Access Compliance Report

Public Rights-of-Way

Intersection ID: 16192	Main Street: DWIGHT_EVANS_RD	Cross Street: PRESSLEY_RD	Location: NW
ADA ID: 9CFACAA06E9E	Ramp Type: PerpDiag	Initial Pass/Fail: Fail	Overall Compliance: No
			Severity Score: 21.25

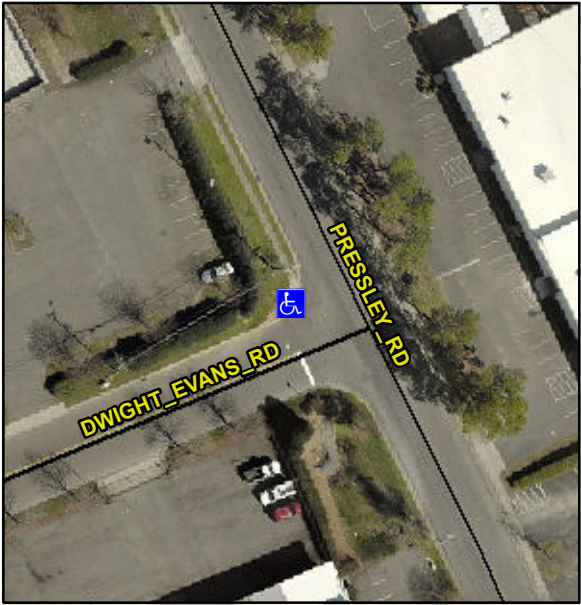
Codes/Mitigation Info/Possible Solution		Field Measurements/Component Compliance			
 <p>Street 1 Name DWIGHT EVANS RD</p> <p>Stop Condition-Street 2 StopSign</p> <p>Street 2 Name PRESSLEY RD</p> <p>Stop Condition-Street 1 None</p>	Possible Solutions:	Remove & Replace Curb Ramp With Two New Directional Ramps or Equivalent.			
	Surveyor Notes:	N/A			
	PROW/ADA:	Not Found, R304.5.1, R304.2.2			
			Compliance	Description	Data
			No	Ramp Length (in)	46.0
			No	Ramp Width (in)	38.0
			N/A	Flare Type LT	N/A
			N/A	Flare Slope LT (%)	N/A
			N/A	Flare Traversable LT?	N/A
			N/A	Landing Length (in)	N/A
			N/A	Landing Width (in)	N/A
			N/A	Landing Slope (%)	N/A
			N/A	Landing X Slope (%)	N/A
			N/A	Landing Curb? (Y/N)	N/A
			N/A	Shared Landing?	N/A
			N/A	Gutter Ponding?	N/A
			N/A	Gutter Lip Ht (in)	N/A
			No	Painted X Walk1?	No
			To S	X Walk 1 Direction	To E
			N/A	X Walk 1 Width (in)	N/A

6.2	X Walk 1 Slope (%)	2.7
			0.7	X Walk 1 X Slope (%)	4.2
			N/A	Ramp inside XWalk1?	N/A
			1.4	Road Slope (%)	N/A
			8.5	Road X Slope (%)	N/A
			N/A	Any Obstructions?	N/A
			N/A	Obstruction Type	N/A
			N/A		N/A
			Yes	Surface Condition? (G/P)	Good
Total Cost:		\$ 3200.00
